PCNNumber: 1319

### Product/Process Change Notification (PCN)

**1. Dual Assembly Sourcing:**

## Package Body Overlay

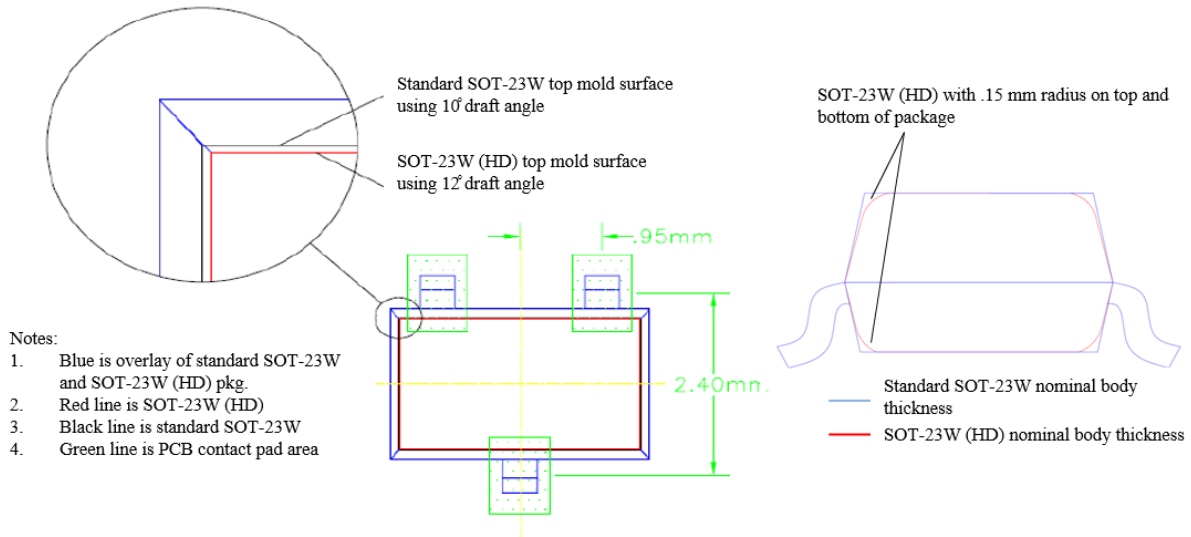
### Standard SOT-23W vs. SOT-23W (HD)

Standard SOT-23W	SOT-23W (HD)
	Nominal	Nominal
<b>Radii</b>	NA	0.15
<b>Draft angle</b>	10°	12°

Top Brand Comparison	
From: Standard SOT-23W	To: SOT-23W (HD)
<p>Example</p> <p><b>01E</b></p>	<p>Example</p> <p><b>101</b></p>

- **Standard SOT-23W Brand:** Last two digits of part number + Temperature range designator
- **SOT-23W (HD) Brand:** Last three digits of the part number
